Subject: Foundation Requirements
688 East 6th Street, St. Paul MN 55106
Ulteig Project No. 10.00796

The purpose of this letter is to report the findings of a structural engineering assessment of the existing foundations located at the residence at the above address.

688 East 6th Street New Footings Plan

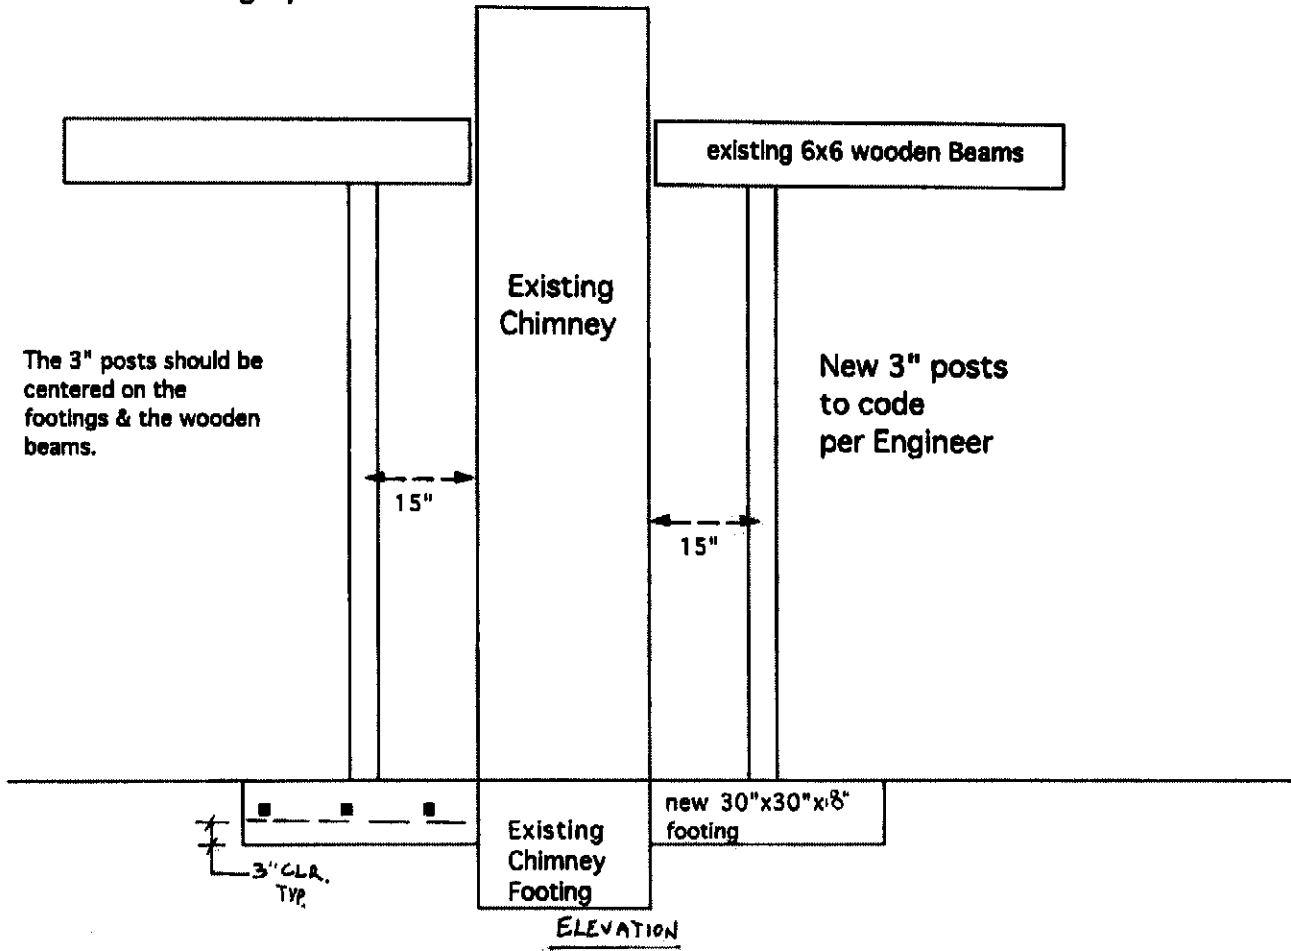
NOTES: Each footing to be 30"x30"x.8' deep, with three # 4 rebar evenly spaced in the N/S and E/S directions, for a total of six rebar per footing. Existing posts are to be replaced with permanent structurally code approved steel posts. A new plinth block is needed under the next post south of the existing chimney.

- b. The existing temporary steel columns should be replaced with 3" diameter permanent columns that have adequate top and bottom plates and positive mechanical fastening.

- c. The new permanent steel columns should be supported on a new 30"x30"x8" deep concrete foundation beneath the slab with (3)#4 reinforcing bars placed in each direction.
